PLAN REVIEW SHEET

Date:	10/31/2007	Staff Contact:	David McDonald
Petitioner:	Selwyn Ave. Presbyterian Church	Telephone:	704-336-6900
Petition:	2008-016	Fax:	704-432-1277
		Email:	dmcDonald@ci.charlotte.nc.us
Location:	+/- 0.64 acres, southeast corner Selwyn Ave and Hassell Place	Attachments:	Shelter_Concrete_Standards.pdf (See 60.02A)
Existing Zoning:	R-3 Single Family Residential		
Requested Zoning:	INST(CD) (Change use of existing house to admin. and/or education uses, plus additional surface parking for church functions)

FIRST SUBMITTAL

STD. NO.	REV.
60.02A

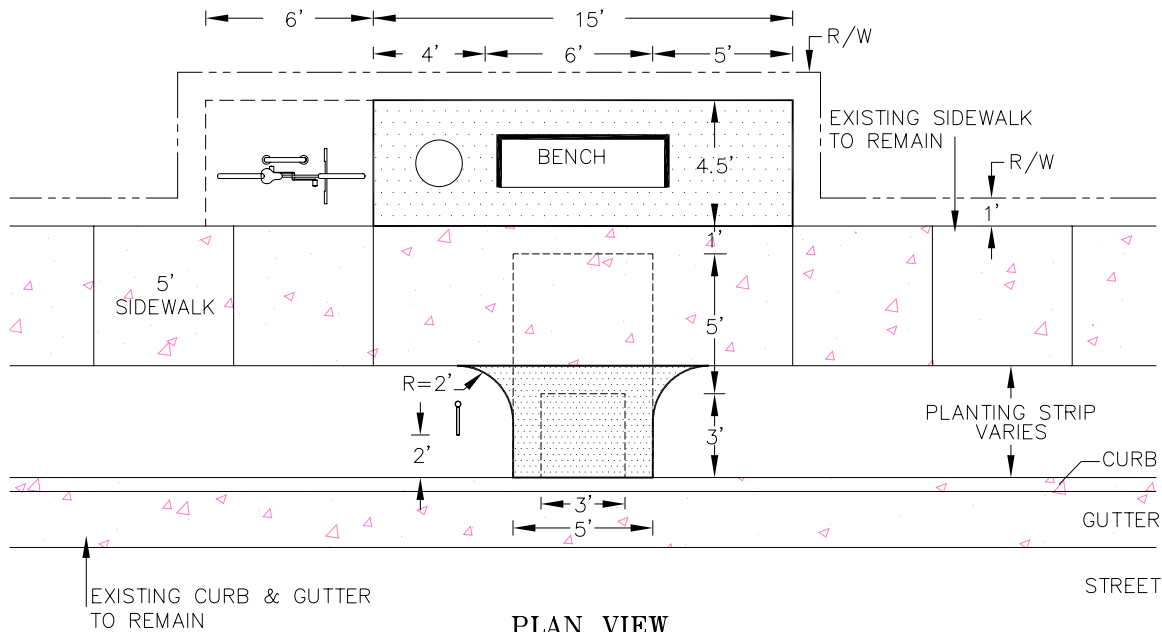
- 1) The petitioner's site is currently served on Selwyn Avenue by Route 18 Selwyn Avenue.
- 2) CATS requests the petitioner to preserve the existing sidewalk and bus stop currently located on Selwyn Ave. (Transit Stop ID #27020).
 - Should the petitioner need to temporarily relocate the existing bus stop, the petitioner should contact CATS, prior to demolition or construction, to coordinate the temporary relocation of the existing CATS bus stop and bus shelter.
- 3) CATS additionally requests the petitioner to construct a bench pad at the location of the existing bus stop on Selwyn Ave. (Transit Stop ID #27020), constructed to CATS Development Standards 60.02 A (see attached).

Please designate such in the site plan and/or accompanying notes. Please contact Leonard Ganther (CATS Operations) @ 704.432.1283 prior to demolition or construction, to coordinate any temporary relocation of the existing bus stop and to coordinate the final location of the new bench pad.
